**Re: Defect Information Report – supplemental information
(FL-464), NHTSA no. 05V-541, Fontaine Modification Sit Down Dual Drive
Conversion**

Section 573.6 Non-Compliance Information Report
FL-464, Fontaine SDDD Steering Pinchbolts; NHTSA no. 05V-541
Supplement No.: 02

Subject: Fontaine Modification Sit Down, Dual Drive Bolts

Models Affected: Specific Freightliner Business Class M2 vehicles manufactured between August 2004 and October 2005 with a right-hand drive position added by Fontaine Modification.

Fig. 3, Pinch Bolt on Intermediate Shaft, Left-Hand Side

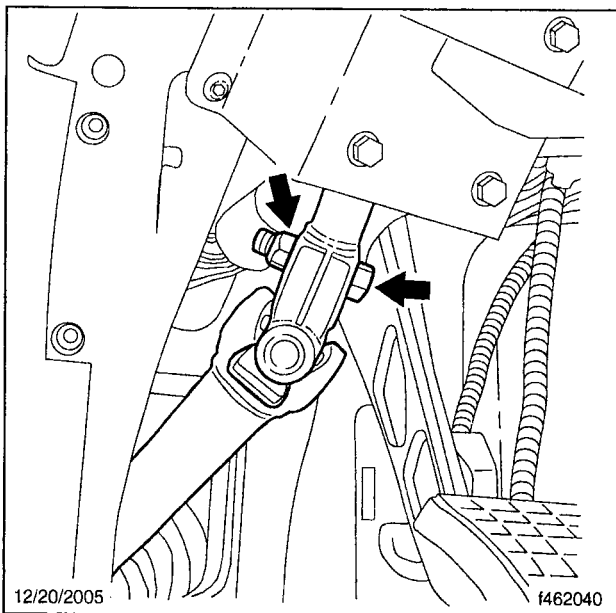
The left-hand steering U-joint pinch bolt that secures the lower steering shaft to the left-hand miter box may have been improperly tightened. Incorrect hardware may have been used to install the steering cross shaft. Loss of a steering shaft pinch bolt or of a cross shaft fastener may cause a loss of steering control and possible vehicle crash without prior warning.

2. Locate the steering pinch bolt that connects the intermediate shaft to the 3-way gear box. See **Fig. 3**. Remove the steering pinch bolt and nut then discard them.

3. Install the pinch bolt and prevailing torque nut from the kit. Tighten the nut to 30 to 35 lbf-ft (40 to 45 N-m).
4. Locate the two through bolts on the steering cross-shaft U-joint, that connects the 3-way gear box on the left side, to the cross shaft. See **Fig. 4**. Remove both of the through bolts, and replace them with two 3/8-inch x 2.25-inch bolts and 3/8-inch stover nuts from the kit. Tighten the nuts to 30 to 35 lbf-ft (40 to 45 N-m).
5. Install the left-hand steering column covers.
Tilt Column: Using the three screws, attach the lower and center steering column covers to the steering column. Using three screws, attach the upper and lower clamshell covers to the steering column.
Fixed Column: Attach the lower and upper clamshell covers to the steering column.
6. Proceed to the steps for the right-hand steering position.

Fig. 6, Cross Shaft with One Through Bolt, Right-Hand Side

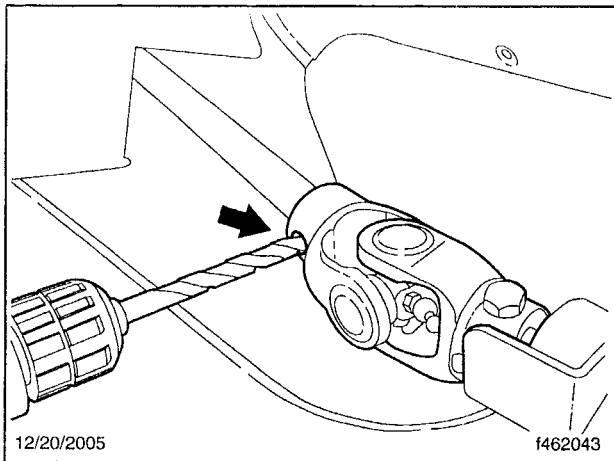
- 3.1 If one through bolt is observed:

Remove the through bolt and replace it with a 3/8-inch x 2.25-inch bolt and 3/8-inch stover nut from the kit. Tighten the nut to 30 to 35 lbf-ft (40 to 45 N·m).

Locate the setscrew in the cross-shaft U-joint yoke (in some cases the setscrew is positioned 90 degrees from the keyway position). Remove the setscrew, then using the hole as a drill guide, carefully drill a 3/8-inch hole through the cross shaft. See **Fig. 6**.

Install the supplied 3/8-inch x 2.25-inch bolt, and 3/8-inch stover nut. Tighten the nut to 30 to 35 lbf-ft (40 to 45 N·m).

Fig. 7, Cross Shaft With Two Through Bolts, Right-Hand Side

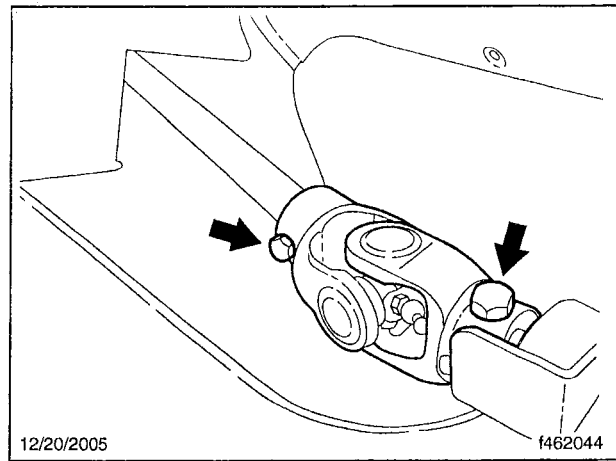
3.2 If two through bolts are observed:

Remove the through bolts and replace them with two 3/8-inch x 2.25-inch bolts and 3/8-inch stover nuts from the kit. Tighten the nuts to 30 to 35 lbf-ft (40 to 45 N-m). See **Fig. 7**.
